ADDENDUM NO. 1

Alden Green House
11580 Walden Ave
Alden, NY 14004

Bid date: January 16th, 2026

FROM: Ben Perkins
Hayes Construction

1 **ELECTRICAL SITE PLAN - COMMUNICATIONS**
1" = 30'-0"

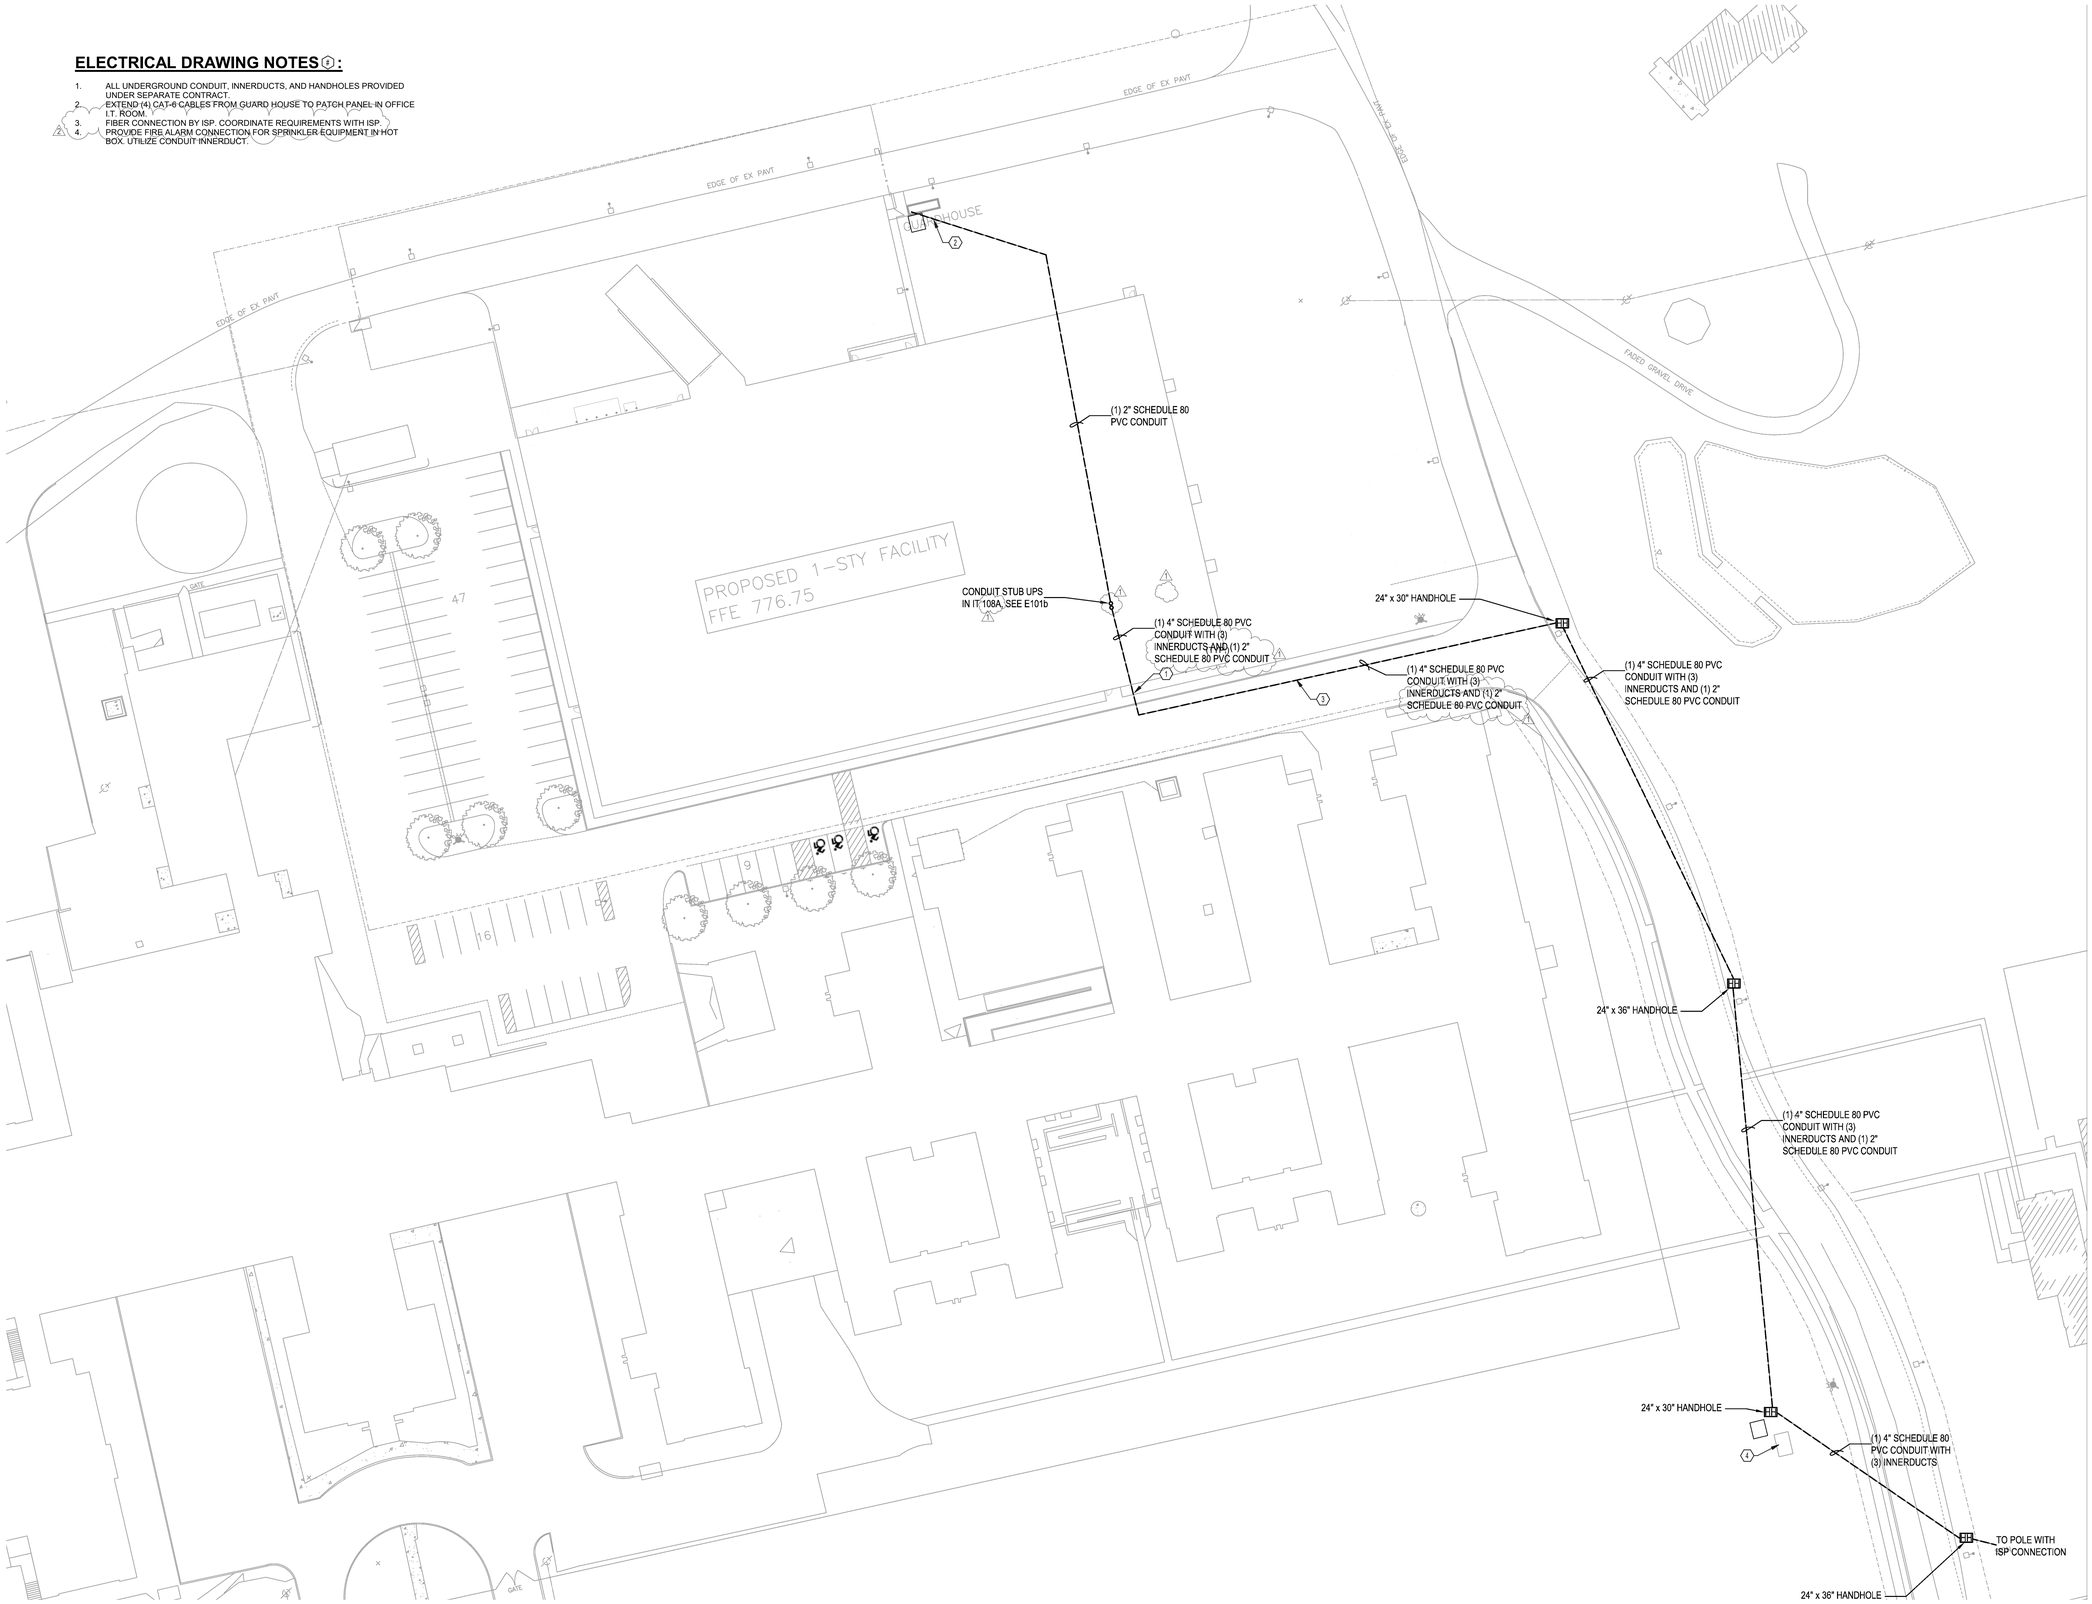
Question: Is electrical contractor responsible for the fiber cable and cat 6 cabling in existing underground conduits referenced on drawing E305? If so, please provide details (strands and type) and specifications for these cables

Answer: EC is responsible for CAT-6 cabling. Fiber to be installed by ISP.
